## LINCOLN CITY/LANCASTER COUNTY PLANNING STAFF REPORT

for March 16<sup>nd</sup>, 2005 PLANNING COMMISSION MEETING

**P.A.S.:** West Van Dorn Heights, Special Permit # 05008, Community Unit Plan

**PROPOSAL:** A Special Permit/CUP for 9 lots, including 24 Build-Through lots, generally located at S. W. 70<sup>th</sup> Street and W. Van Dorn Street.

**RE BUILD-  
THRU SITE  
PLAN**

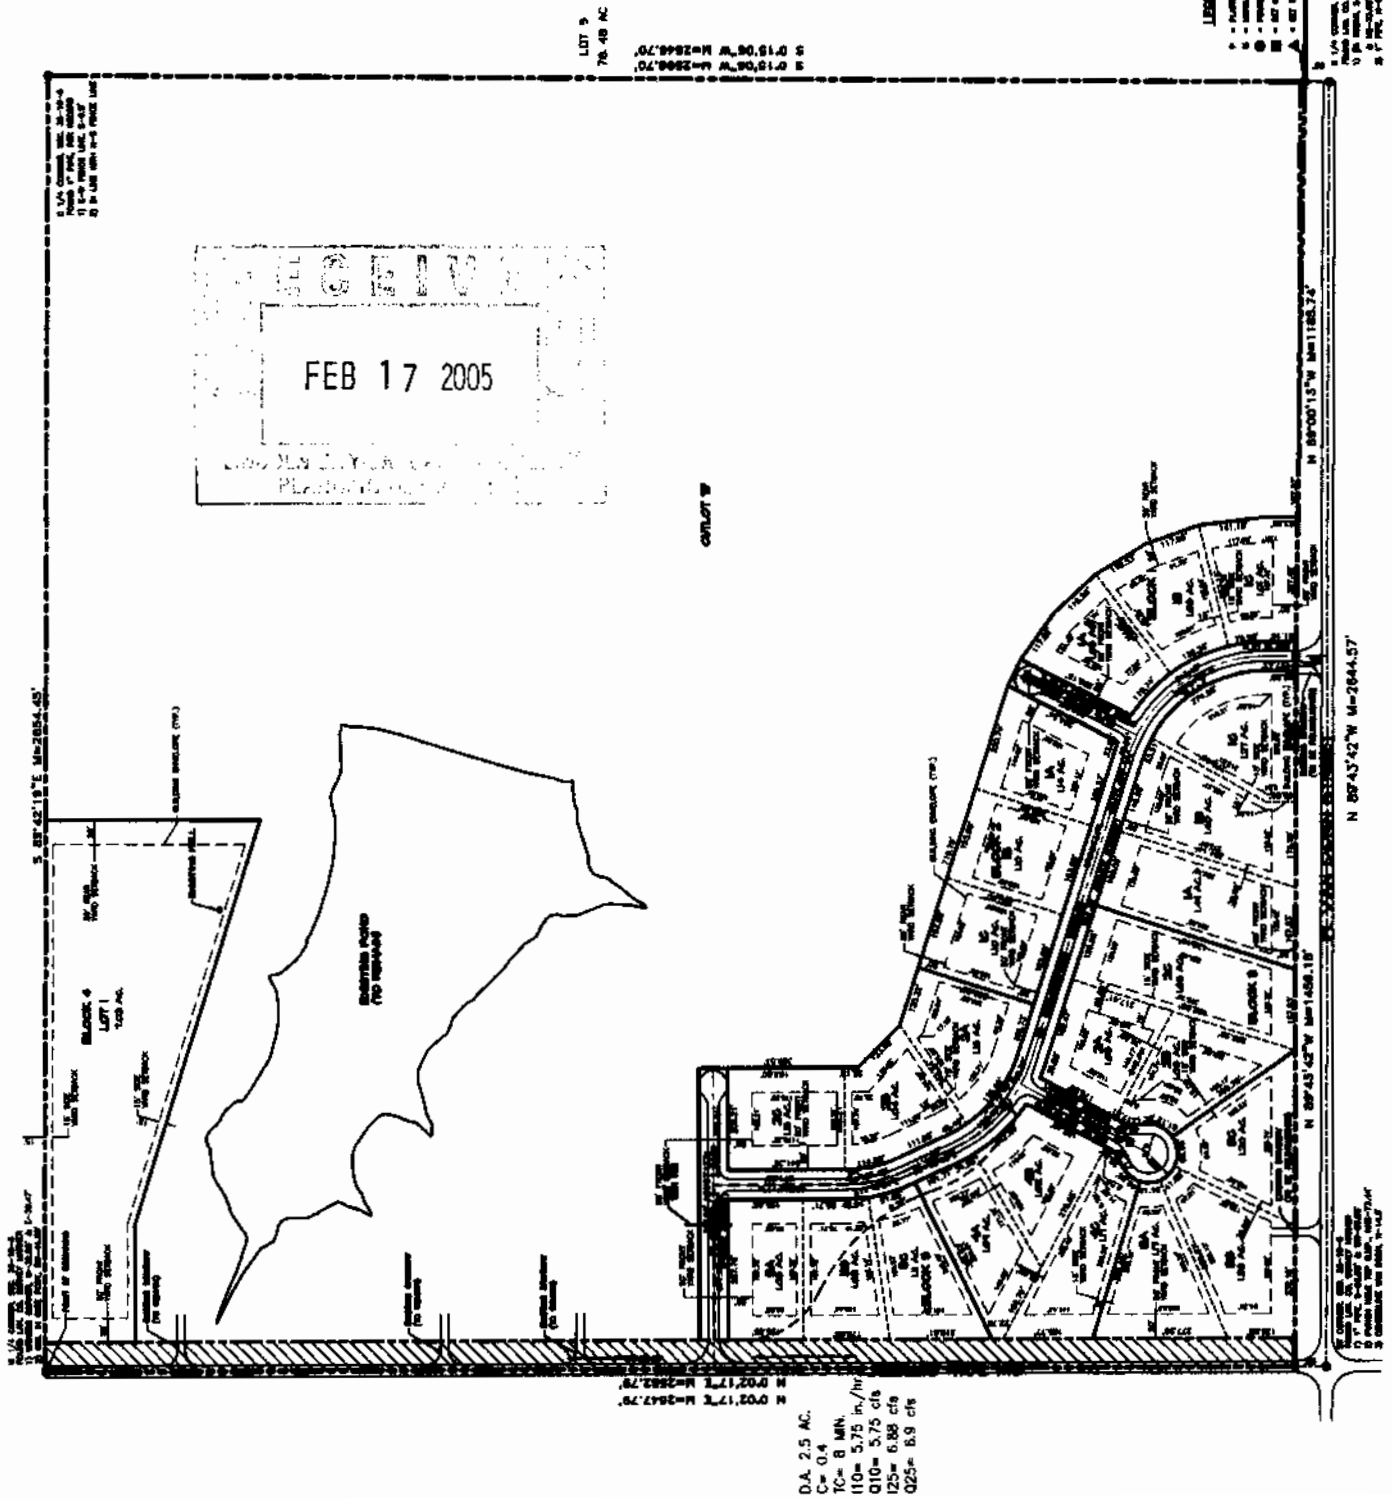
5.1.3 Show the "Build-Through" lots in Lot 1, Blk 4.

5.1.4 Show the future half mile road off S. W. 70 and off Van Dorn.

5.1.5 Show the flood pool elevation of the pond.

5.1.6 Add a note that the outlot is designed for future platting to a density of about 460 dwellings and for future subdivision of the acreage lots.

5.1.7 Show the tree masses.

5.1.8 Add to Outlot "B" that it is reserved for future residential development..

5.1.9 Adjust the lots to show the Urban Reserve at 75% of the Parcel area.

5.1.14 Show a drainageway, future storm sewer and future sanitary sewer easement along the creek in Outlot "B".

- 1) *General Note No. 10* should be revised to allow access to SW 70<sup>th</sup> Street from Lot 1, Block 4 Instead of Lot 9 and allow access for the farm drives.

- 2) *General Note No. 13* should be revised to require 50.00 feet radius returns at SW 70<sup>th</sup> Street and at West Van Dorn Street.
- 3) The radius of the interior intersections is shown as 25.00 feet on the drawing and should be 30.00 feet.

- 4) Developer will be required to install all required signs.
- 5) The existing pavement of West Van Dorn Street is shown incorrectly with respect to the section line. The centerline of the pavement is approximately 15.00 feet north of the section line. There is no SW 70<sup>th</sup> Street south of West Van Dorn Street.

- 6) Should pavement be considered, the County Engineer will determine the appropriate requirements prior to installation.
- 7) The existing right-of-way on West Van Dorn Street is based on 50.00 feet from the existing street centerline. A dedication of 10.00 feet shall be shown to provide the required 60.00 feet from the existing street centerline.

(3.1) The minimum flood corridor easement needs to be shown for the drainage way that runs through the site as a portion of it drains more than 150 acres.

(4.2) Adequate sight distance does not appear to be provided at the intersection of SW 70 and Benelli Lane. Information needs to be provided showing that adequate sight distance is provided.

(4.4) A build through configuration needs to be shown for Lot 1 Block 4 at the northwest corner of the plat. Also, this approximately the half mile line so a possible location for the half mile road should be

**GRADING PLAN**

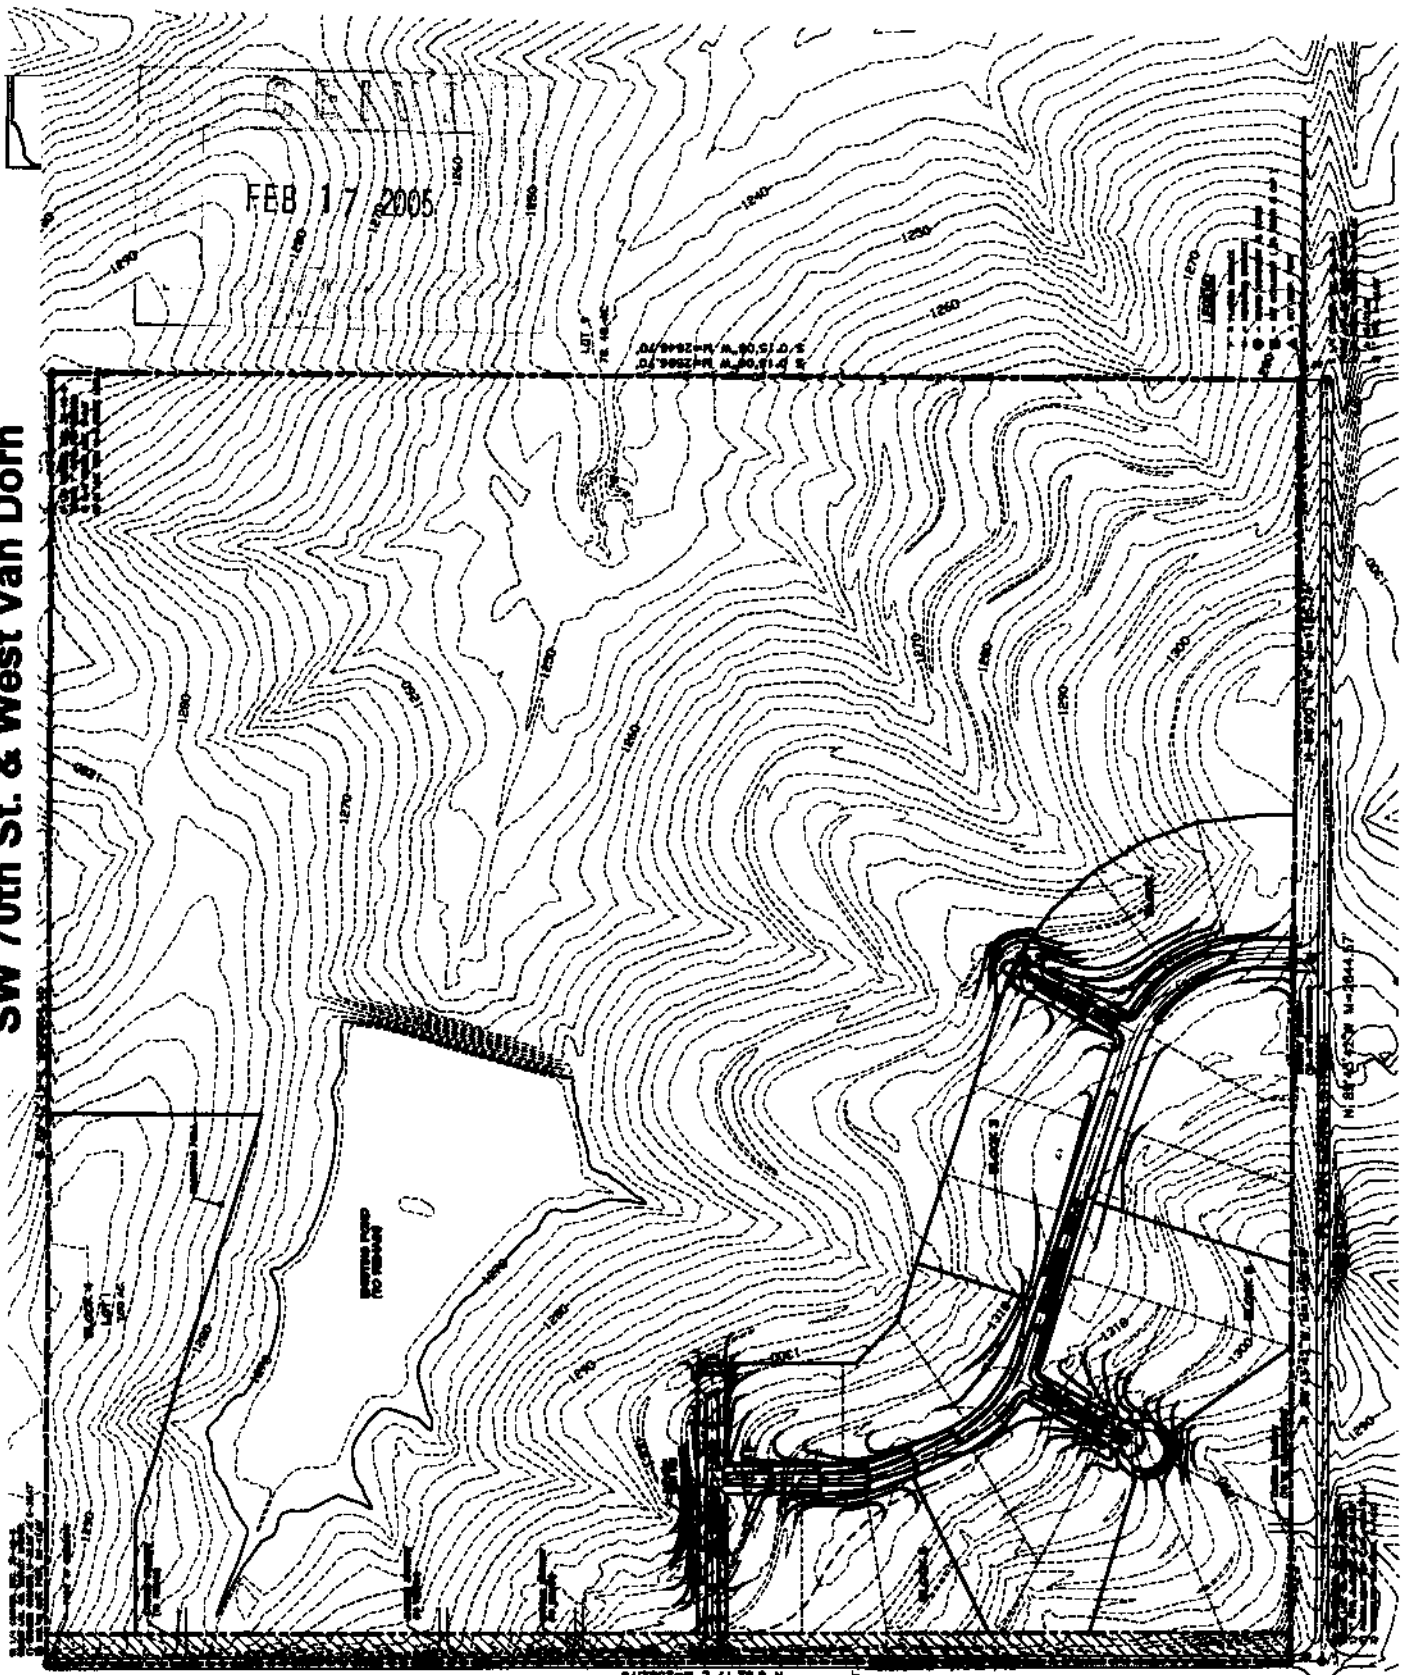
(3.2) The grading plan needs to be revised to show the necessary lot grading to accommodate the future urban local streets and the future urban arterial sections for SW 70<sup>th</sup> and West VanDorn.

(3.3) A storm sewer easement needs to be shown from SW 69<sup>th</sup> Place to West VanDorn.

(4.1) Street grades meeting arterial street standards need to be shown for SW 70<sup>th</sup> Street and West VanDorn Street. The lot grading adjacent to SW 70<sup>th</sup> Street and West VanDorn needs to be revised to reflect the proposed future urban cross section.
